COMMITTEE	Planning Development Management Committee
DATE	21 April 2022
EXEMPT	No
CONFIDENTIAL	No
REPORT TITLE	Aberdeen Planning Guidance: Draft Prime Four Business Park Development Framework 2021
REPORT NUMBER	PLA.22.045
DIRECTOR	Gale Beattie
CHIEF OFFICER	David Dunne
REPORT AUTHOR	Laura Robertson
TERMS OF REFERENCE	6. develop and adopt non-statutory development management guidance (supplementary planning guidance)

Prime Four Business Park - Revised Framework November 2021

PLA/22/045. Aberdeen Planning Guidance: Draft Prime Four Business Park Development Framework		
Summary of responses and issues arising from public consultation held from 17 December 2021 until 31 January 2022		
<i>Key issue</i>	<i>Officers Response</i>	<i>Action as a result of Representation</i>

Figure 14: Existing & Proposed Connectivity

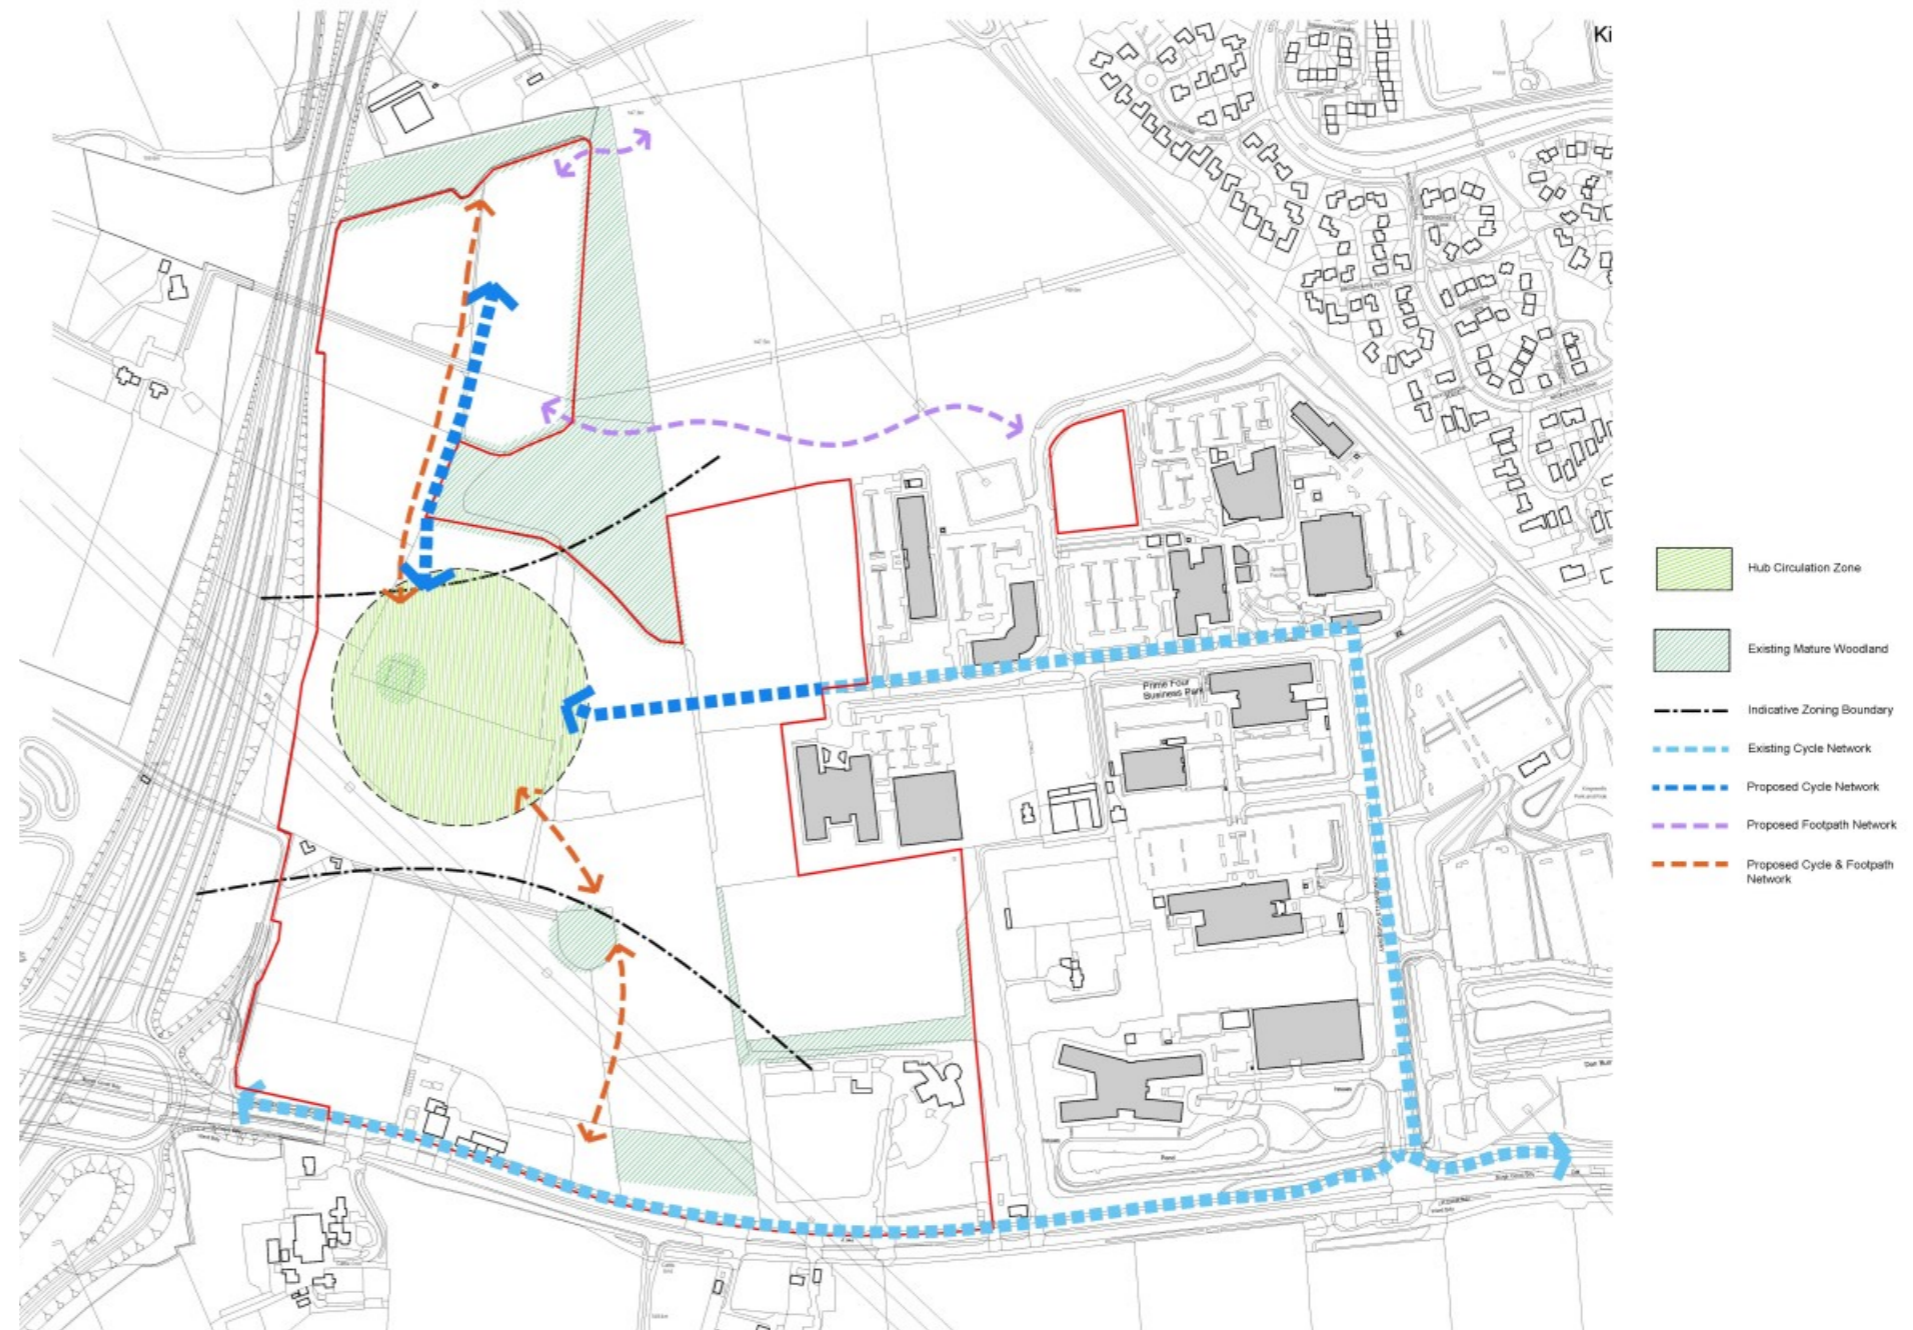
6.2 Any new development should not preclude and ideally should enhance any proposals for mixed- use walking and cycling path	Comment accepted.	On page 22, Figure 14 – add in an extra “proposed cycle network” dashed line
